## **Ballast Water Management Systems**

### **Object of Amendment**

Rules/Guidance for Ballast Water Management Installations

**Amended-Original Requirements Comparison Table (Ballast Water Management Systems)**

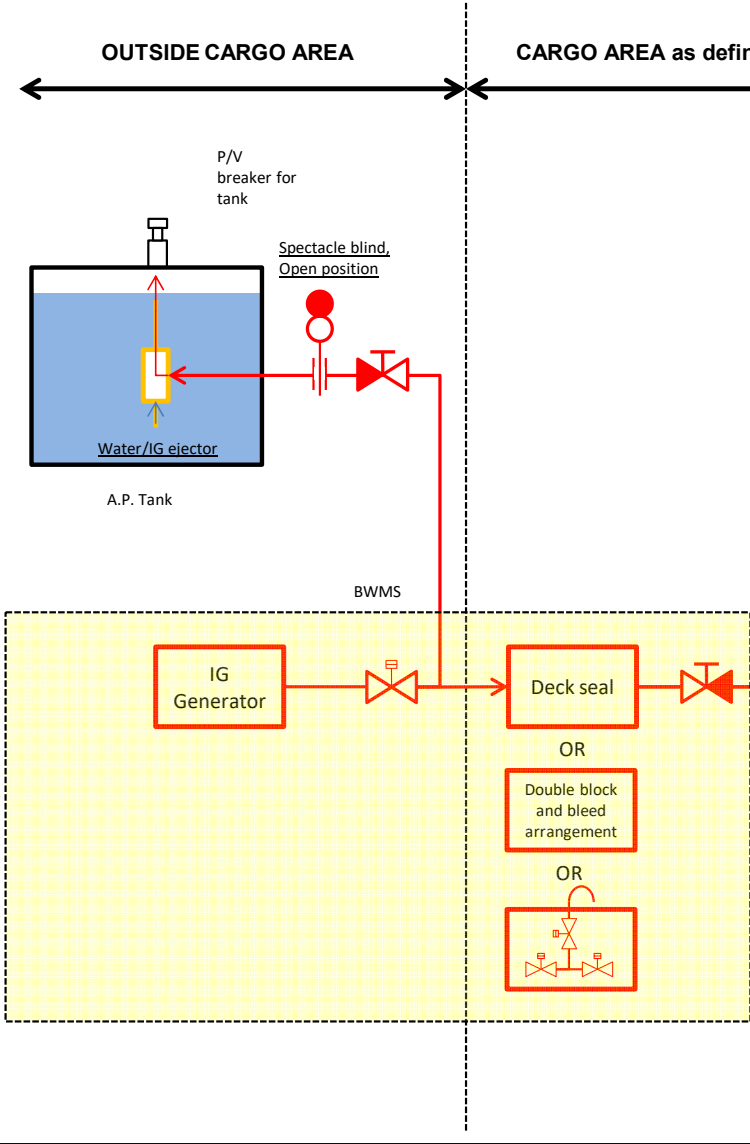
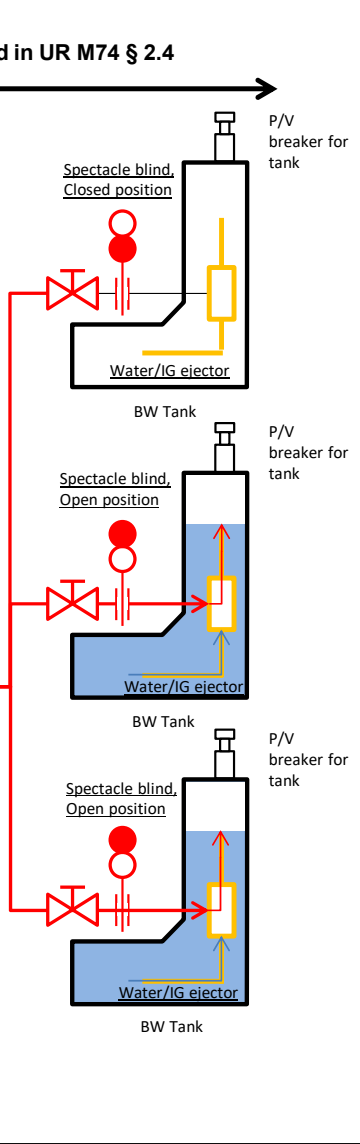
Amended	Original	Remarks
<p style="text-align: center;">Fig. 2.1.1-1(4) <i>BWMS</i> Technology Group 3b: In-line De-oxygenation (Injection of Inert Gas from either an Oil-fired Inert Gas Generator or Inert Gas from Treatment of the Flue Gas from Main or Auxiliary Boilers)</p> <p><b>Ballasting operation:</b></p>  <p><b>De-ballasting operation:</b></p> 		<p>UR M74 (Rev.3) Annex II clarification for VOS</p>

Amended	Original	Remarks
<p><b>Ballasting operation:</b></p> <p><b>De-ballasting operation:</b></p>

Amended	Original	Remarks
<p style="text-align: center;">Fig. 2.1.1-1(5) <i>BWMS</i> Technology Group 3c: In-tank De-oxygenation with IGG</p>		<p>UR M74 (Rev.3) Annex II</p>

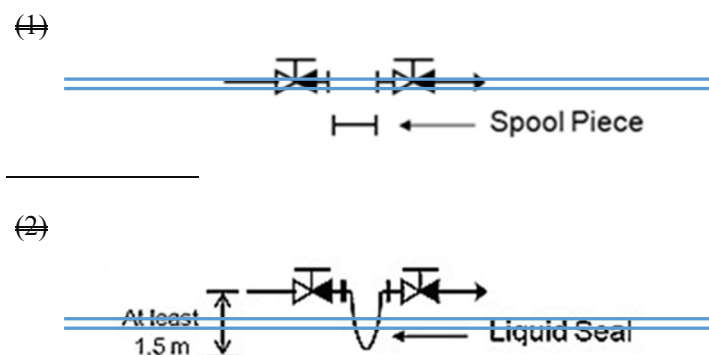
Amended	Original	Remarks
<p style="text-align: center;"><b>OUTSIDE CARGO AREA</b></p> 	<p style="text-align: center;"><b>CARGO AREA as defined in UR M74 § 2.4</b></p>

Fig. 2.2.3-1 Means of Appropriate Isolation

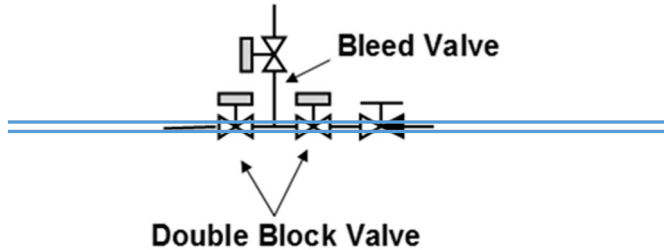
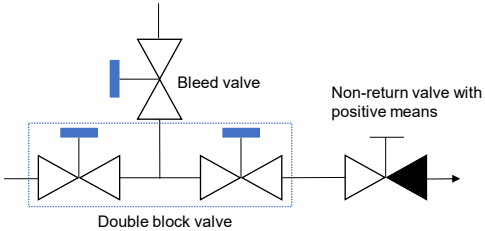
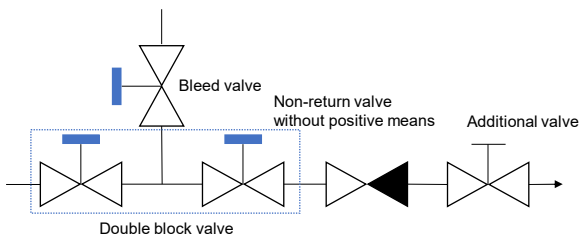
Amended	Original	Remarks
<p>additional valves having such means of closing may be provided between non-return valves and spool pieces <b>(Fig. 2.2.3-1(2))</b>.</p> <p>(2) Two non-return valves with positive means of closing in series with liquid seals at least 1.5 m in depth <b>(Fig. 2.2.3-1(3))</b>. As an alternative to such positive means of closing, additional valves having such means of closing may be provided between non-return valves and liquid seals <b>(Fig. 2.2.3-1(4))</b>. For ships operating in cold weather conditions, freeze protection is to be provided for water seals (portable heating systems may be accepted for this purpose).</p> <p>(3) Automatic double block and bleed valves and non-return valves with positive means of closing <b>(Fig. 2.2.3-1(5))</b>. As an alternative to such positive means of closing, additional valves having such means of closing may be provided after non-return valves <b>(Fig. 2.2.3-1(6))</b>.</p>	<p>additional valves having such means of closing may be provided between non-return valves and spool pieces.</p> <p>(2) Two non-return valves with positive means of closing in series with liquid seals at least 1.5 m in depth <b>(Fig. 2.2.3-1(2))</b>. As an alternative to such positive means of closing, additional valves having such means of closing may be provided between non-return valves and liquid seals. For ships operating in cold weather conditions, freeze protection is to be provided for water seals (portable heating systems may be accepted for this purpose).</p> <p>(3) Automatic double block and bleed valves and non-return valves with positive means of closing <b>(Fig. 2.2.3-1(3))</b>. As an alternative to such positive means of closing, additional valves having such means of closing may be provided after non-return valves.</p>	<p>UR M74 (Rev.3) para.3.2.3.1.1, 3.2.3.1.2 and 3.2.3.1.3</p> <p>The current figures (1) to (3) are replaced with new figures (1) to (6).</p>

Amended	Original	Remarks
<p>(3)</p> 		
<p><u>(1) Means of appropriate isolation for 2.2.3-9(1)</u></p> 	<p><u>(2) Alternative to positive means for 2.2.3-9(1)</u></p> 	
<p><u>(3) Means of appropriate isolation for 2.2.3-9(2)</u></p> 	<p><u>(4) Alternative to positive means for 2.2.3-9(2)</u></p> 	
<p><u>(5) Means of appropriate isolation for 2.2.3-9(3)</u></p> 	<p><u>(6) Alternative to positive means for 2.2.3-9(3)</u></p>
